## **ADDENDUM #5**

Citrus Grove Road Phase 2  
Project No. 2025-04, Bid No. 25-749

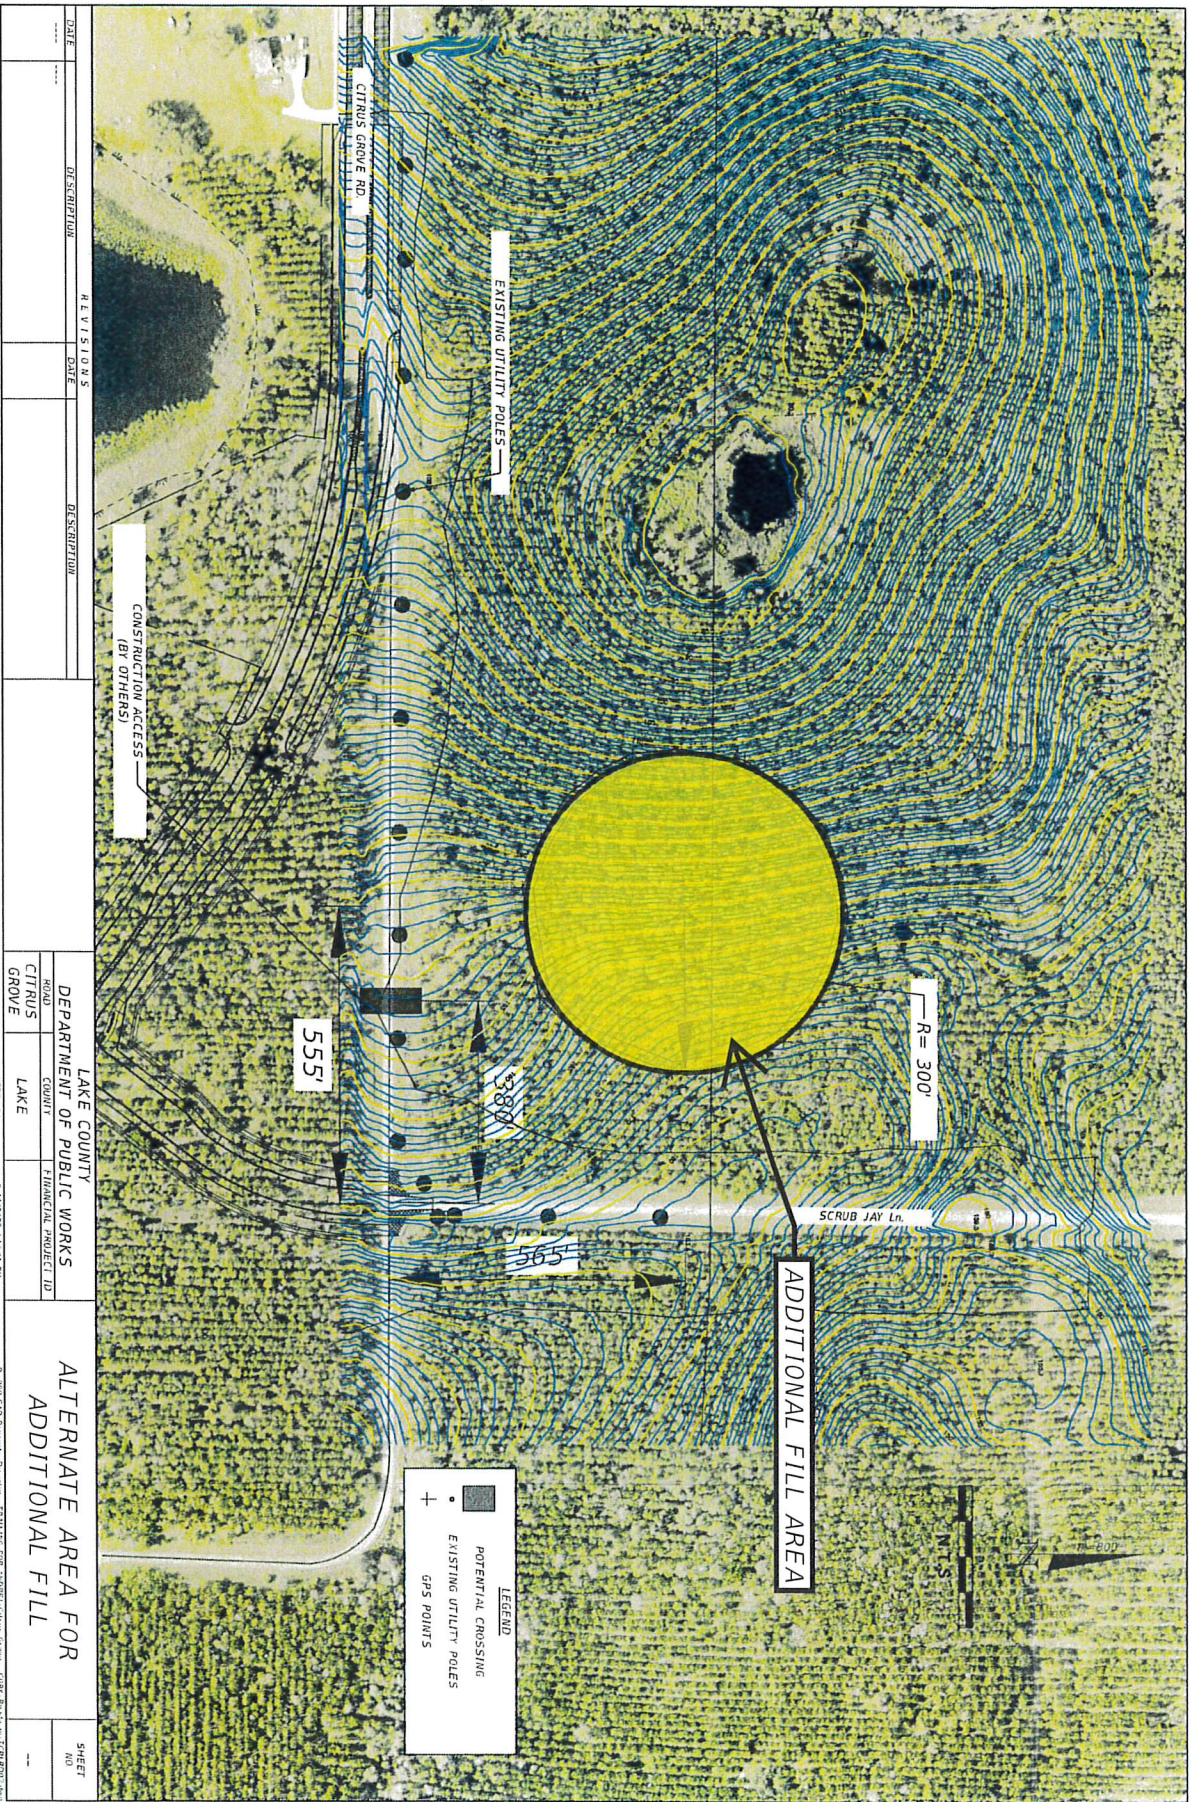
**Q4:** What is being done with the existing roadway, and can a plan be put out showing to get an accurate SY??

**Q5:** What are the specs on the temp asphalt? Also, can there be a plan put out showing the temp asphalt in a smaller scale so we can get an accurate SY?

**Q13:** Can there be a demo page showing the limits of milling on the old roadway, without that it will not be accurate.

**Q16:** Can the demo page show the guardrail that needs to be removed? Can this also be added to the bid tabs?

**Q17:** To echo Question #4 of Addendum #2, please consider a larger area for the Excavation Stockpile Area as the quantity of material to be stockpiled will result in a fairly high stockpile and will be difficult to maintain.

**Q19:** What is the purpose of including the drawing titled ALTERNATE ACCESS EXHIBIT in the Addendum #4?

**Q27:** Can the county please provide the plan sheets for the 4" milling area?

**Q29:** It states that there is an attached map for placing additional excess fill, but added page is not clear...there's an added page labeled "Alternative Access" but says nothing about placing excess fill. There is a circle indicted with 300' radius that is not labeled...is this the location?

**A4:** Please see attached aerial showing the existing road. At the end of construction this roadway will need to be removed. This area will need to be milled 4" deep, graded and Lake County will allow seed and mulch in these areas as opposed to sod as long as there is no erosion.

**A13:** See attached aerial.

**A16:** Please see attached aerial. As stated in Addendum #1, "Contractor shall add a line item to the bid tabulation sheet in Division W of the bidding document for any items that may be required but not shown on the tabulation sheet.

**A17:** Please see attached aerial depicting where any excess fill material should be stored.

**A19:** This attachment shows a second location for storing fill material. Please see attached aerial which more clearly indicates where any excess fill material should be stored.

**A27:** Please see the attached aerial. The 4" milling is to be done on the existing segments of existing Citrus Grove Road where not in conflict with proposed Citrus Grove Road.

**A29:** Please see attached aerial which more clearly indicates where any excess fill material should be stored.
